8112A-04B

HP 8112A Pulse Generator 50 MHz

Recommended Replacement (P/N 1DD6-0002) of A1 U200, U220 and U240 Timing ICs Require Modifications

5180-2410

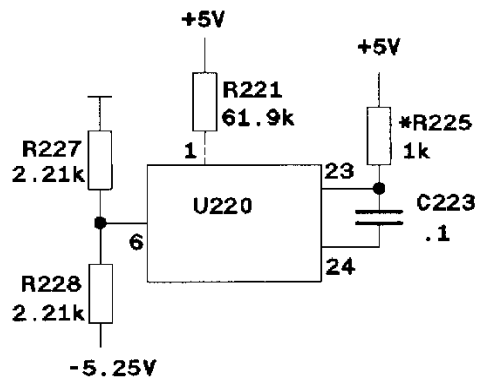
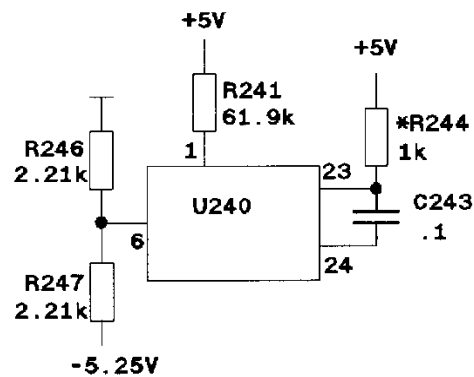
HP part number 5180-2410 is used for A1 U200, U220, and U240. All three ICs have to be replaced by 1DD6-0002, even if only one IC is defective. Perform the following modification steps:

- 1) Delete A1 C203, C223, and C243.
 - 2) Delete A1 R213, R227, R228, R246, and R247.
 - 3) Replace A1 R211, R225, and R244 with 0698-2441 R-FXD 215 ohms.
